ADDENDUM #2

NORTH TRUCKEE DRAIN REALIGNMENT PHASE 1

BID #13/14-007 – PWP# WA-2014-011

This addendum is to notify all potential proposers of clarifications made to the Bid documents as stated below.

11-14-CITY OF SPARKS, NEVADA, PUBLIC WORKS DEPARTMENT

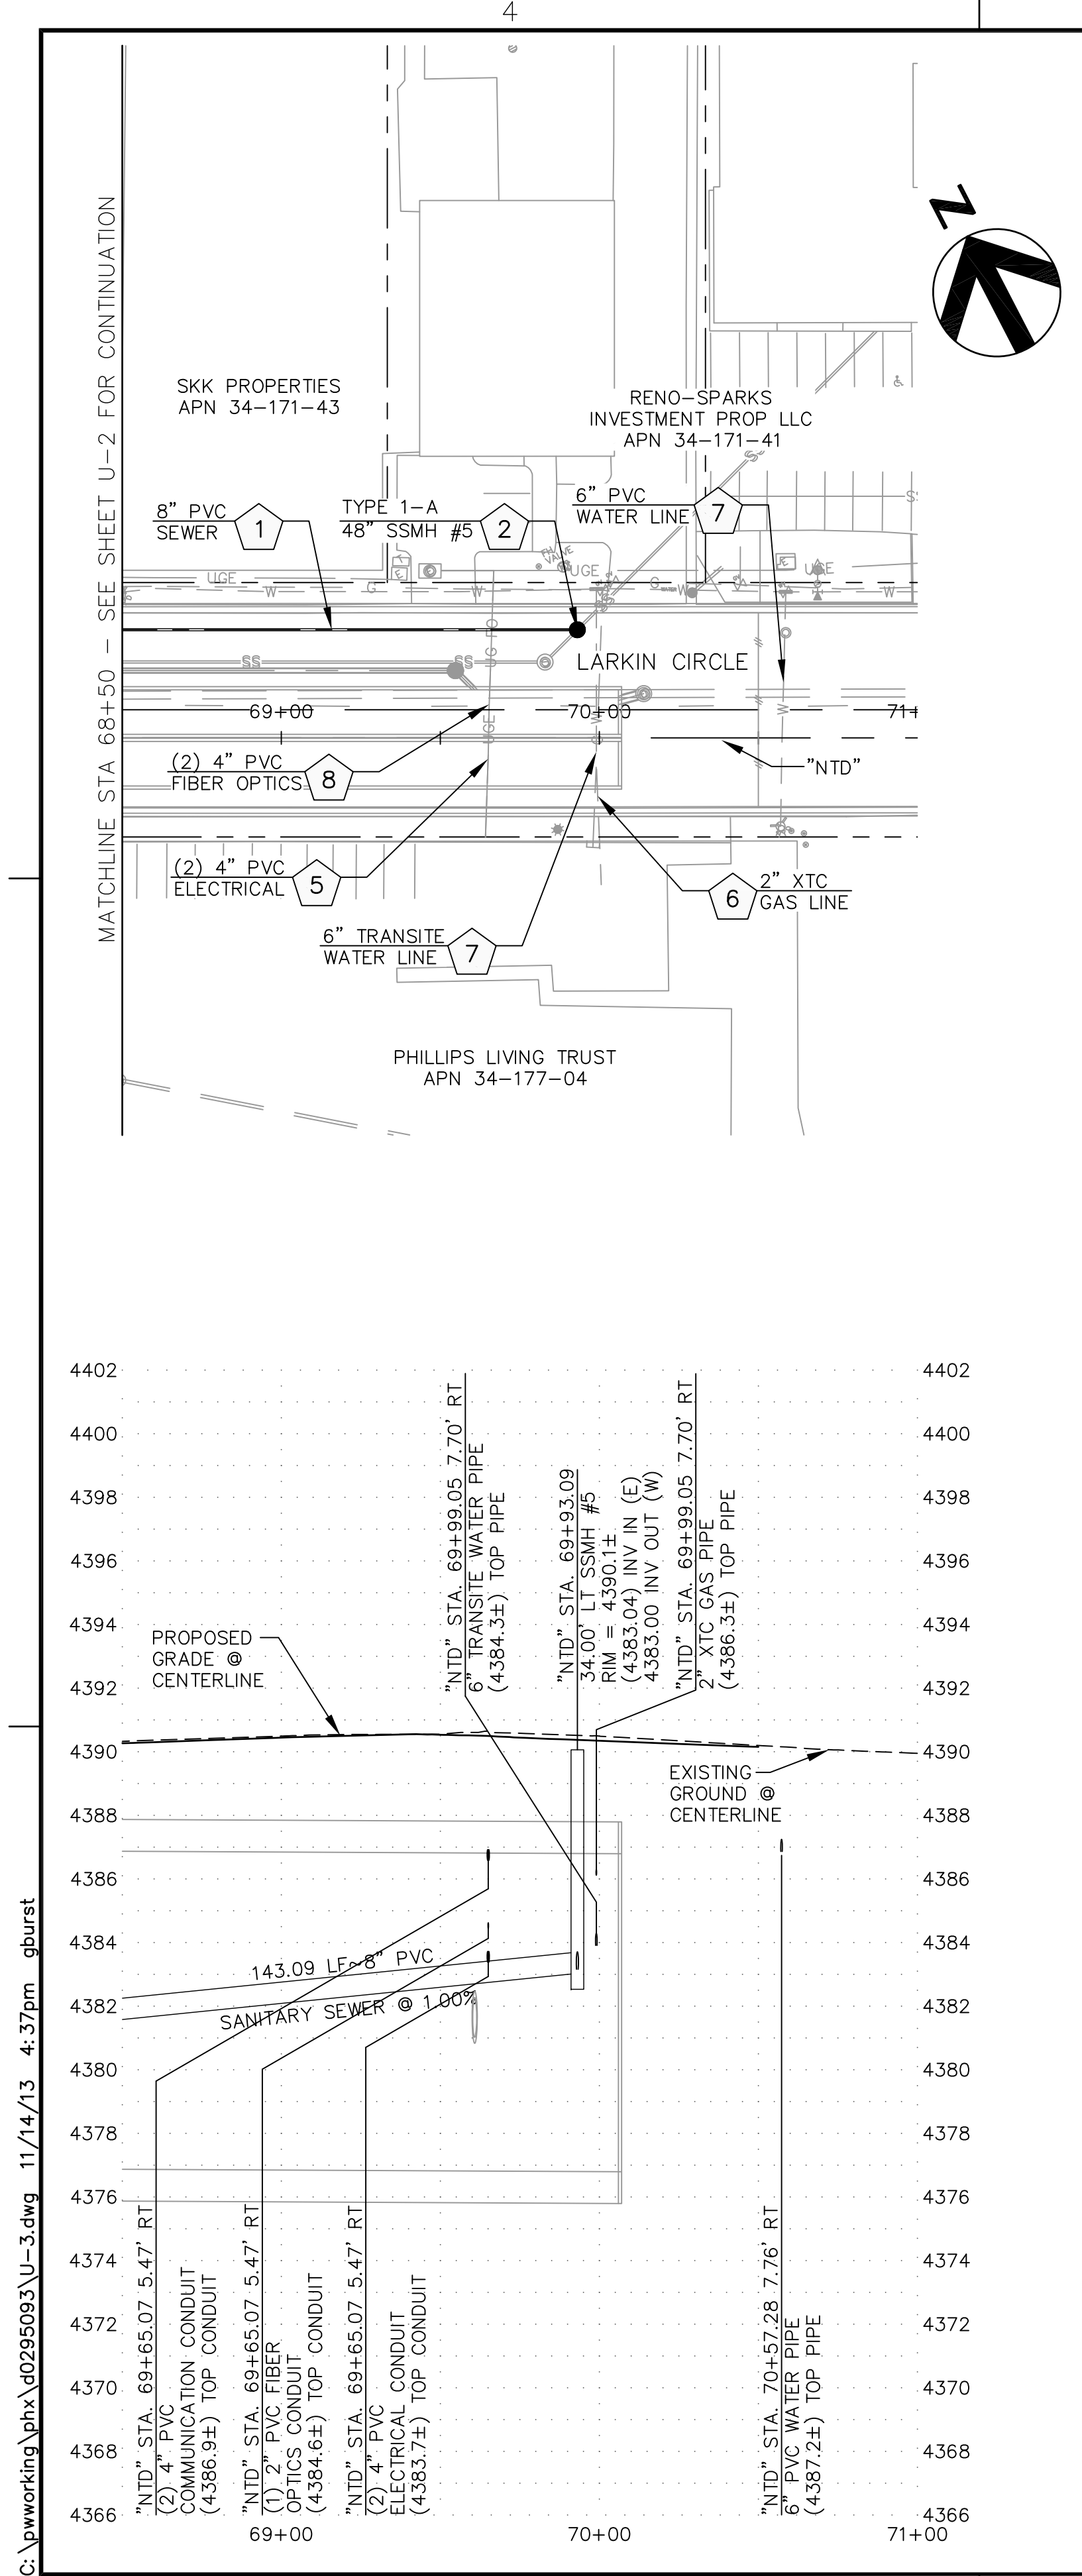
18. Sheet DT-6 – The Portland Cement Concrete details (top half of the sheet) were all removed and replaced.
19. Sheet DT-7 – The lower middle detail titled "Loop Detector Notes, Layout and Details" was added.

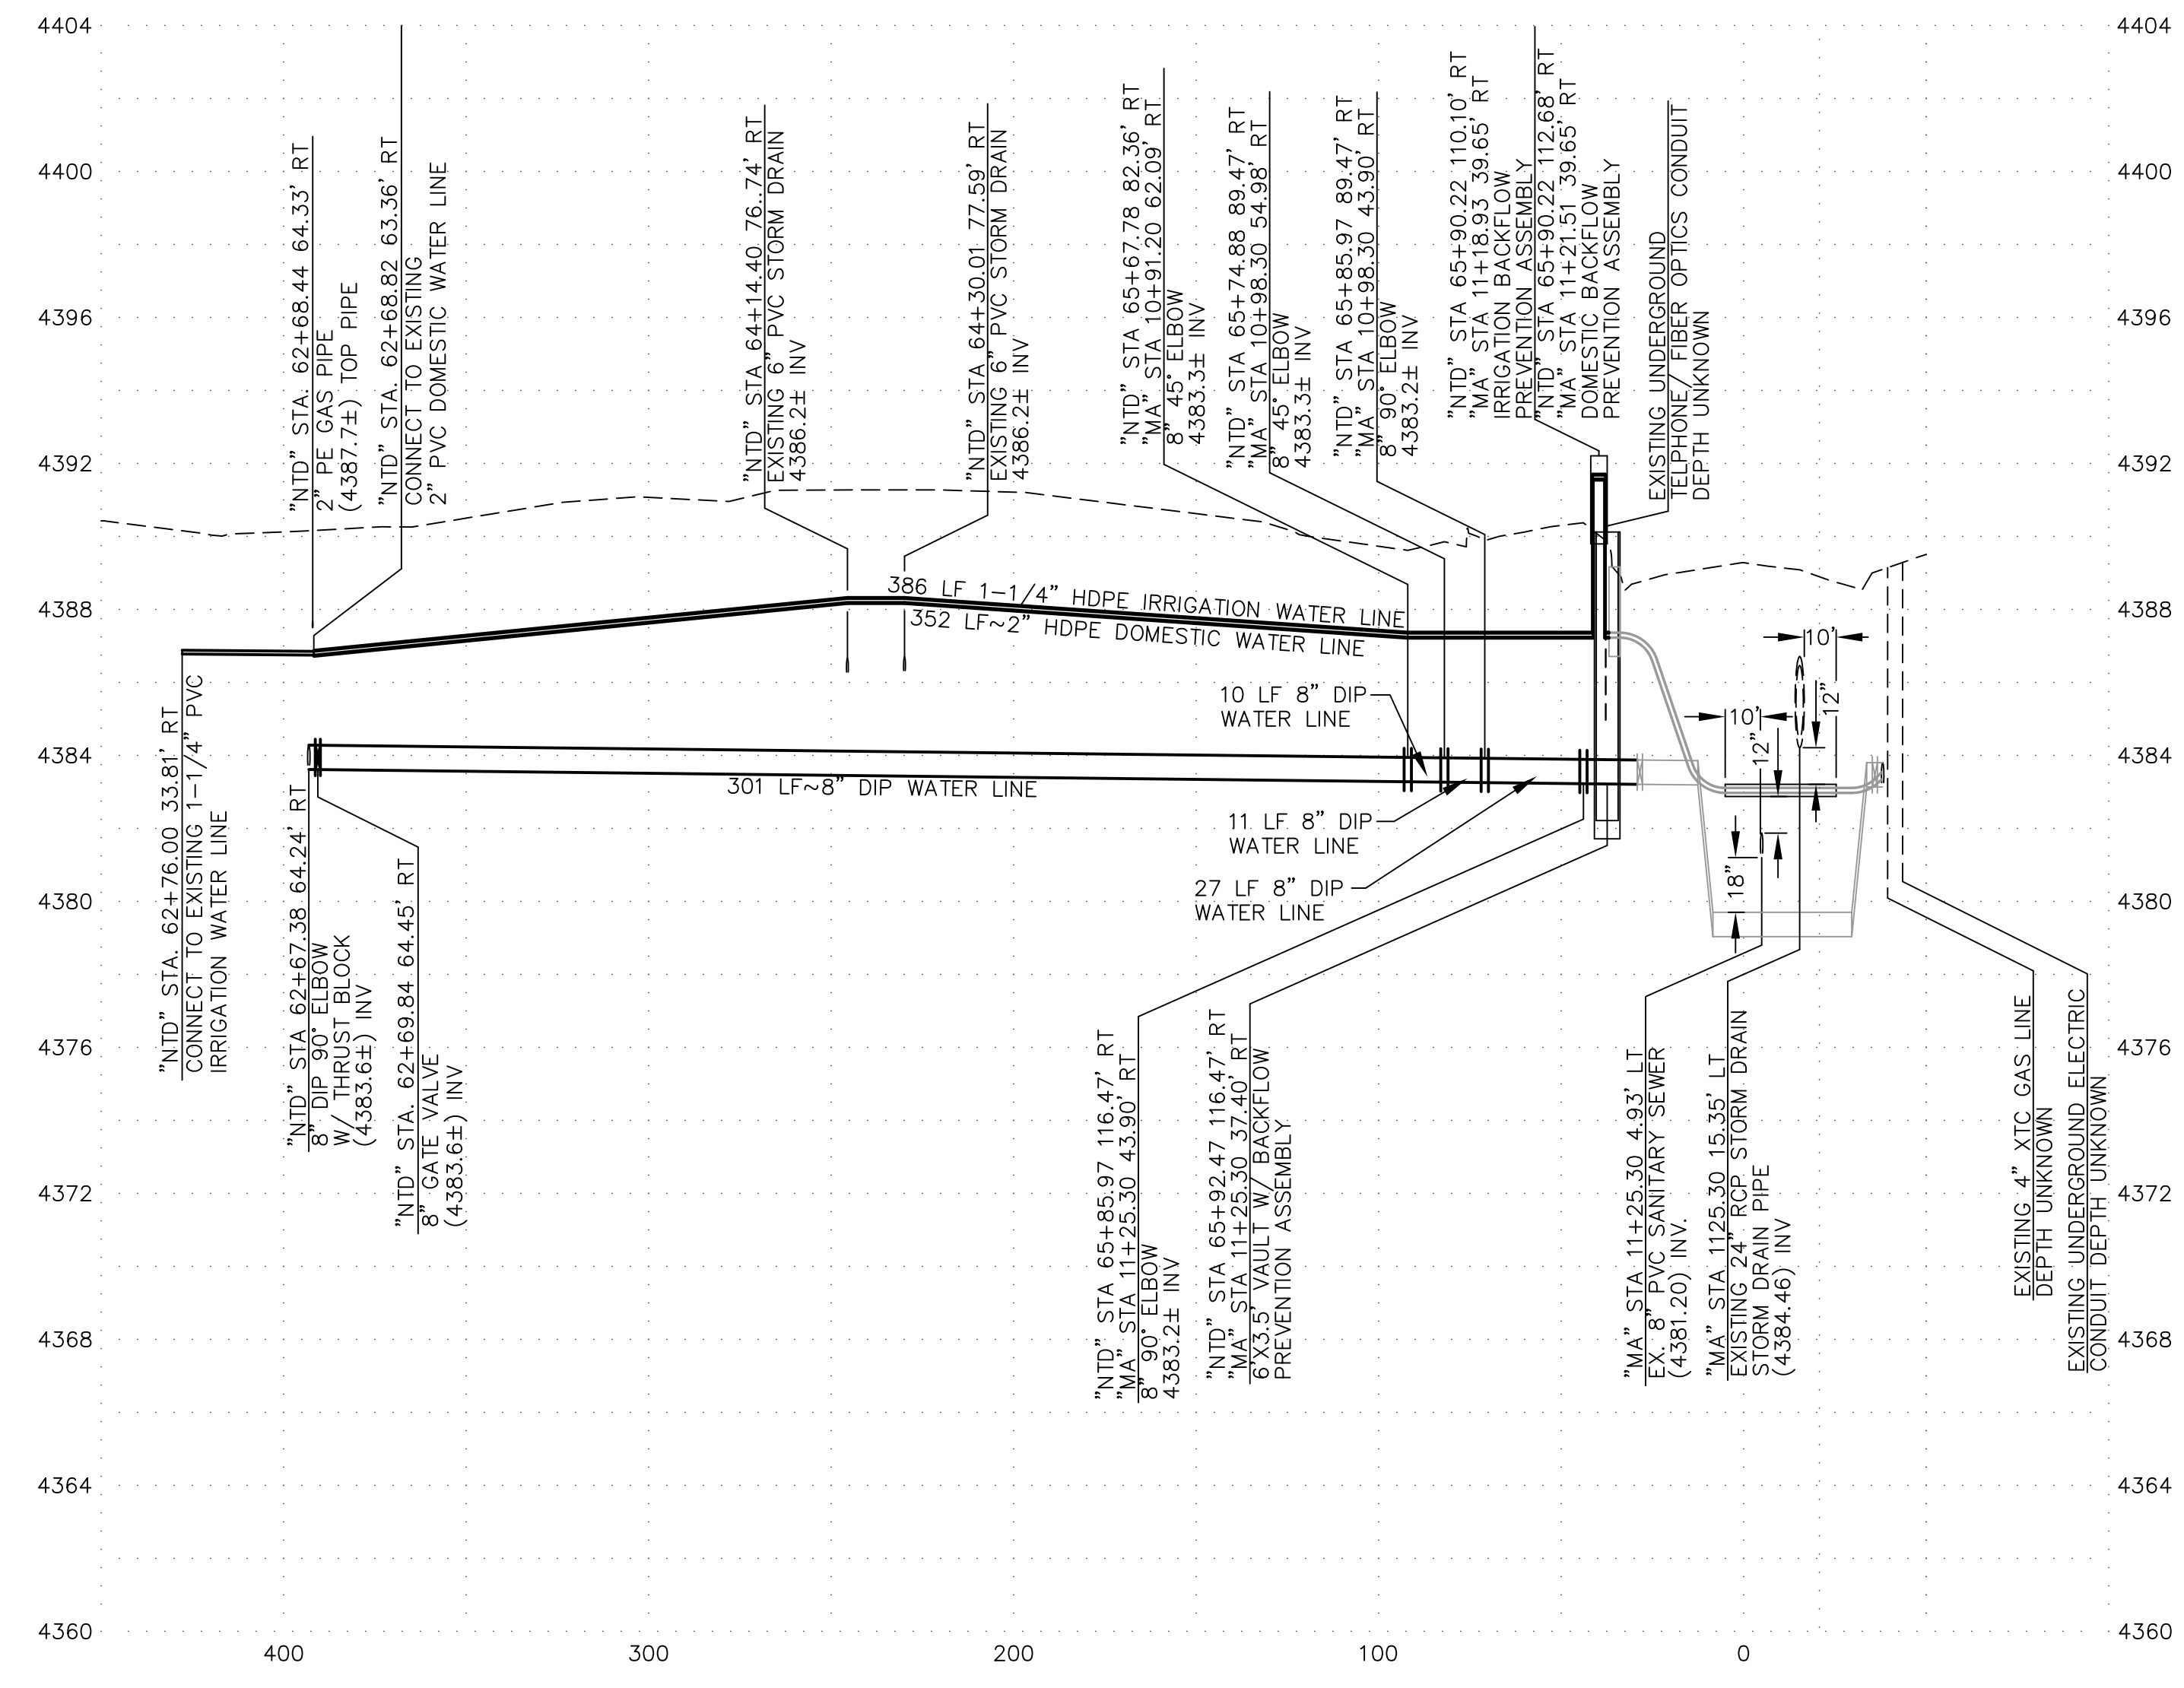
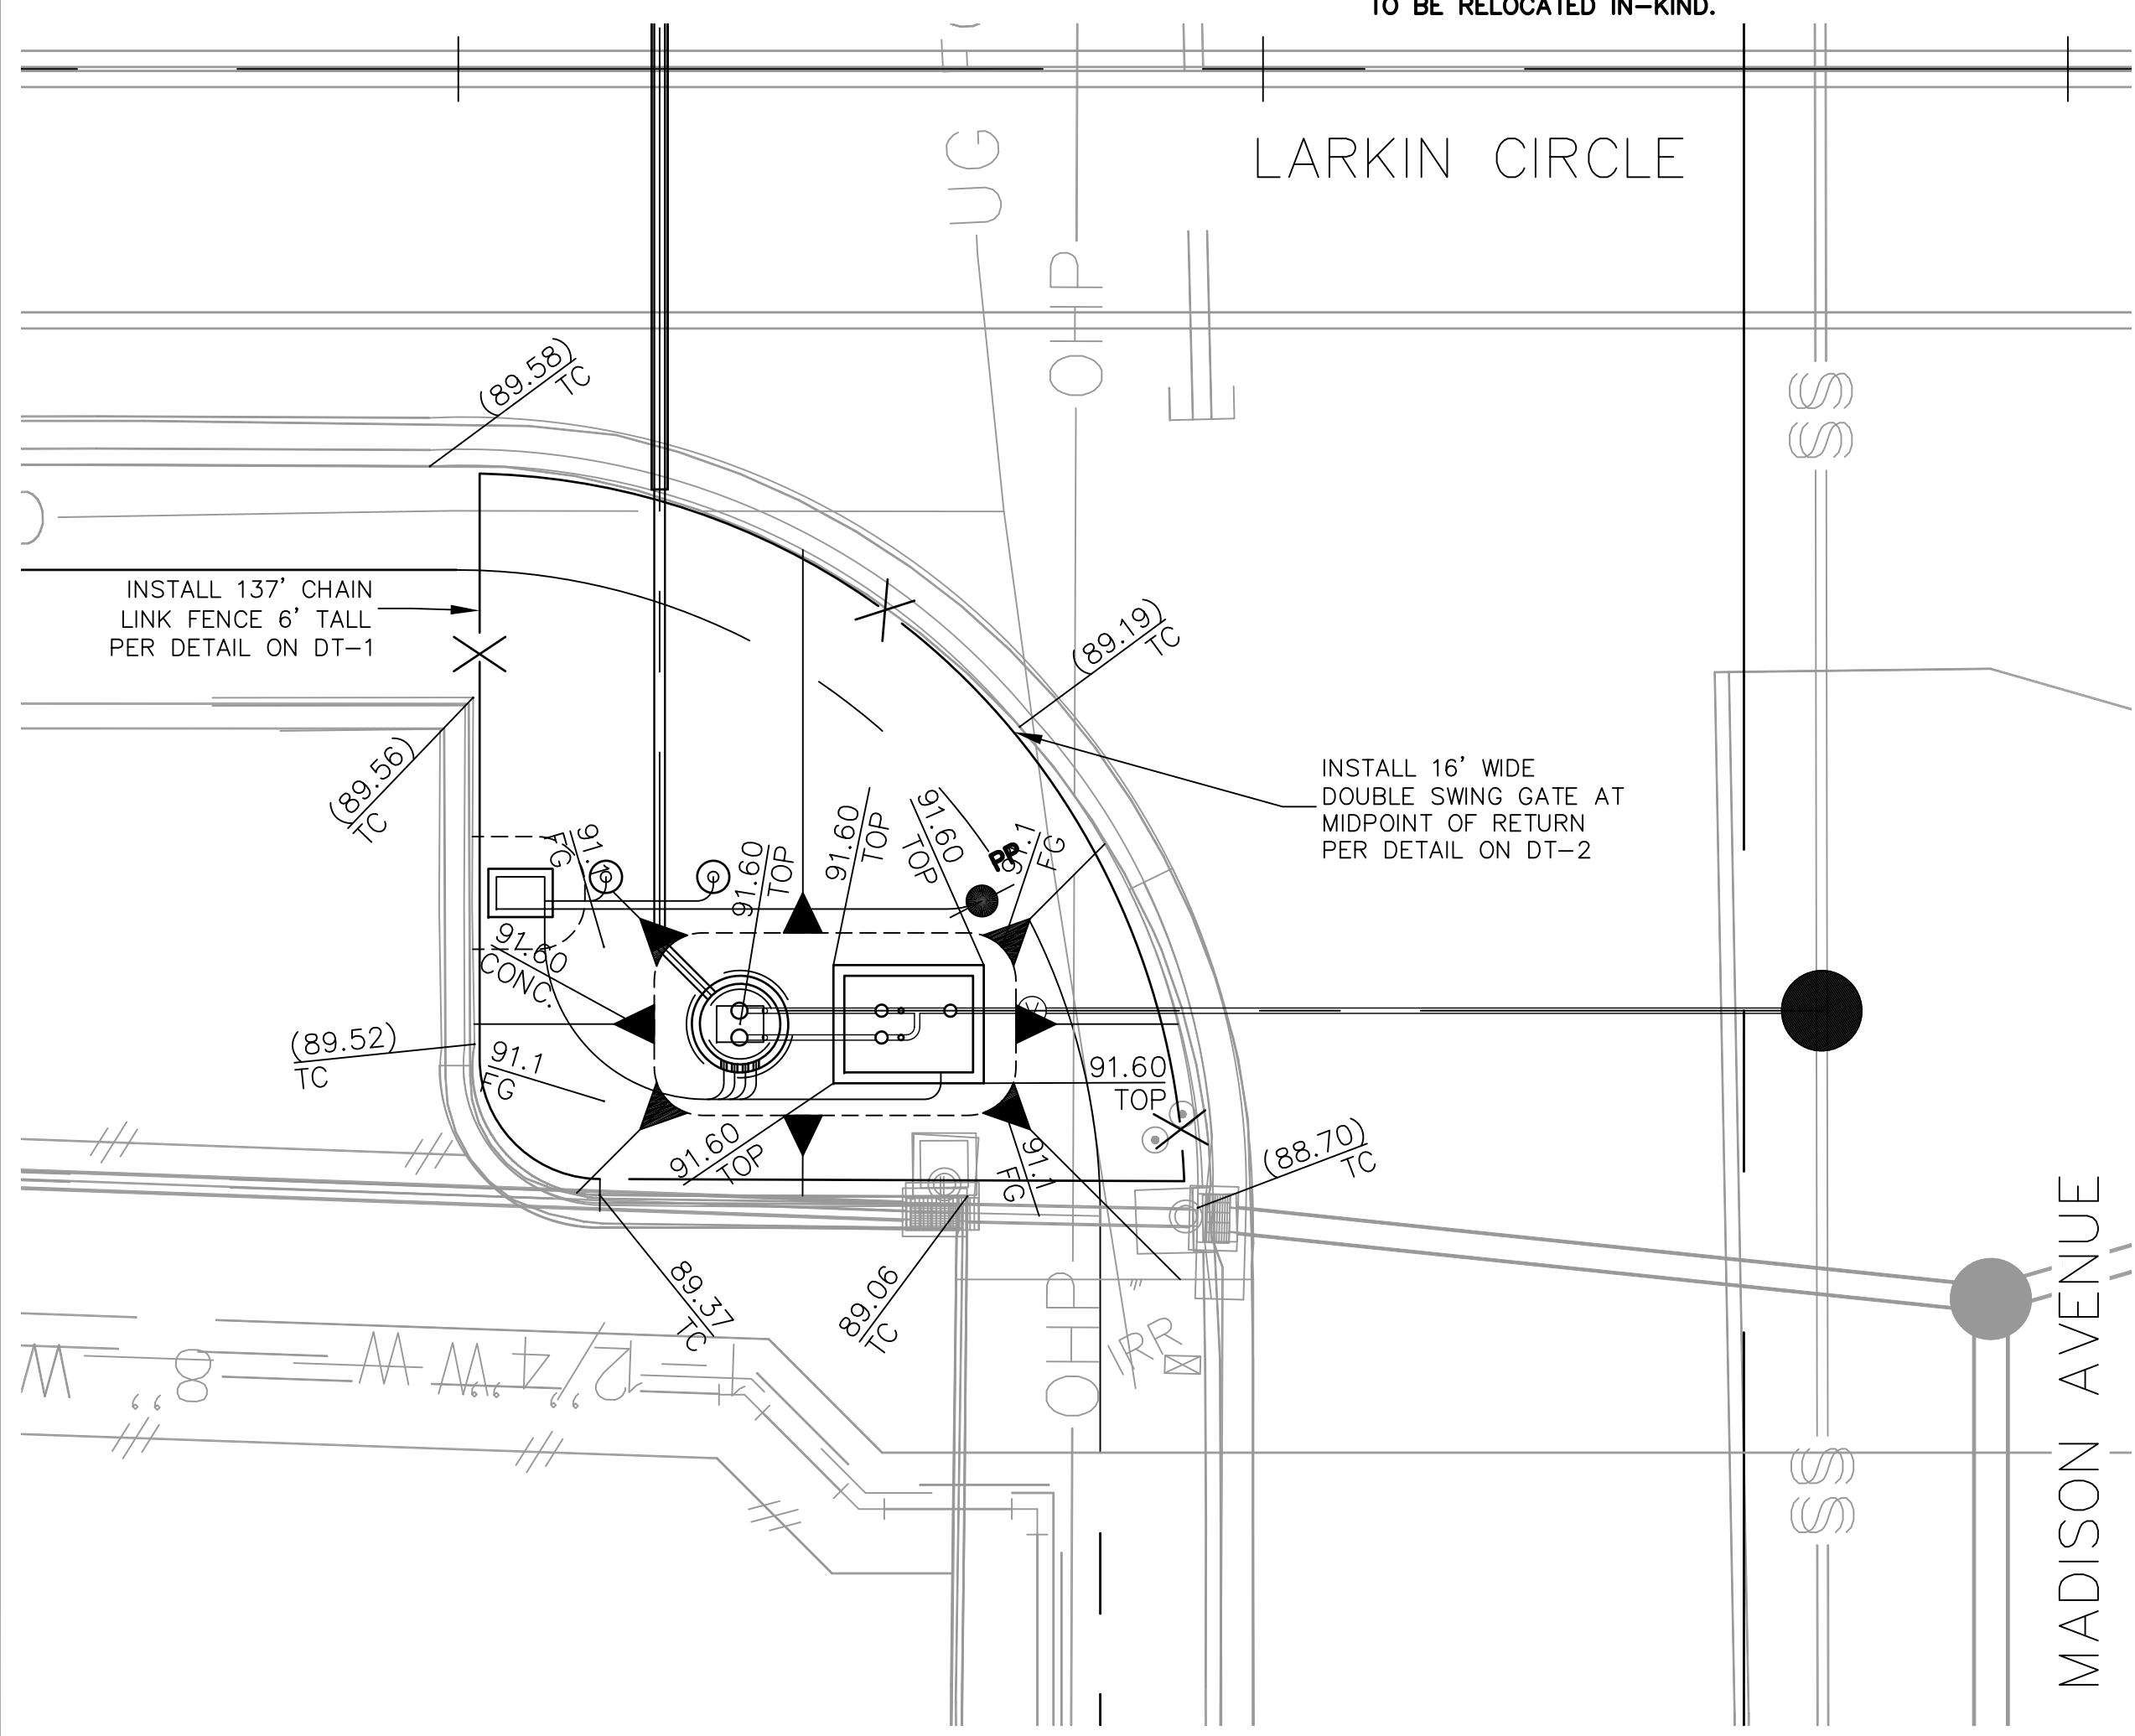
20. Sheet U-3 – In the upper middle and upper right details, sanitary sewer lift station enclosure fencing was highlighted.
21. Sheet U-4 – In the lower left detail, sanitary sewer lift station enclosure fencing was highlighted and notes were added.
